REMARKS

Claims 1-8 and 10-17 were examined and reported in the Office Action. Claims 1-8 and 10-17 are rejected. Claims 1-2, 4, 8, 10 and 16-17 are amended. Claims 1-8 and 10-17 remain.

FIG. 2.

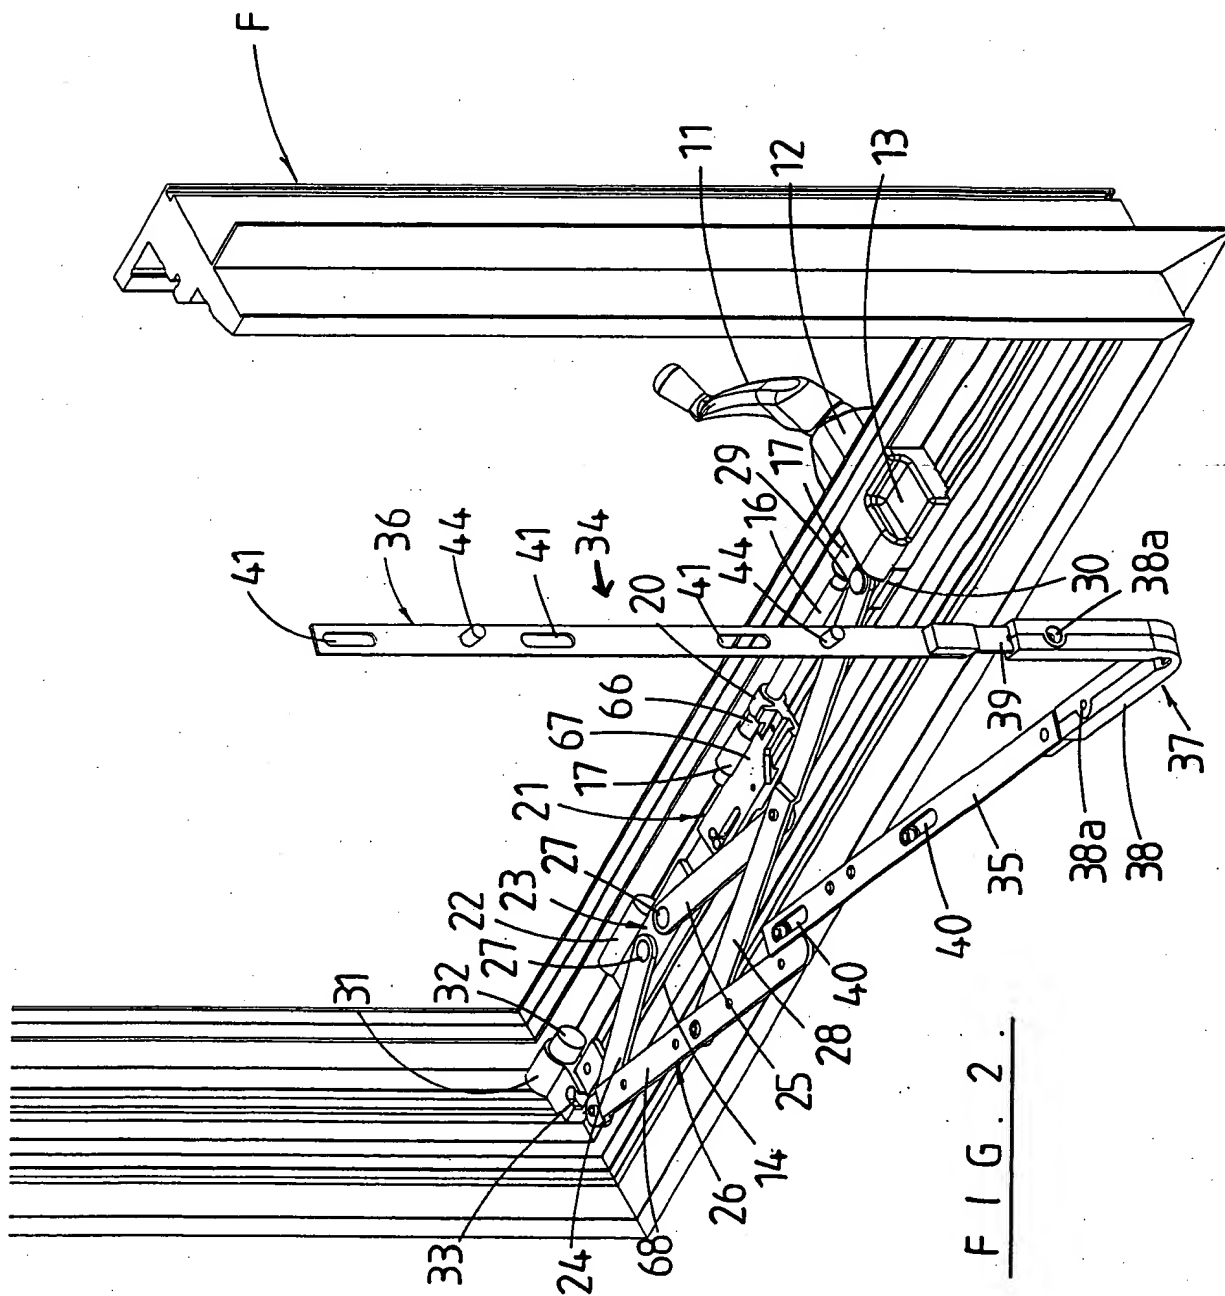
It is asserted in the Office Action that in Figure 2, reference numeral 34 has no lead line. Applicants have amended Figure 2 to include a lead line for reference numeral 34. Approval is respectfully requested.
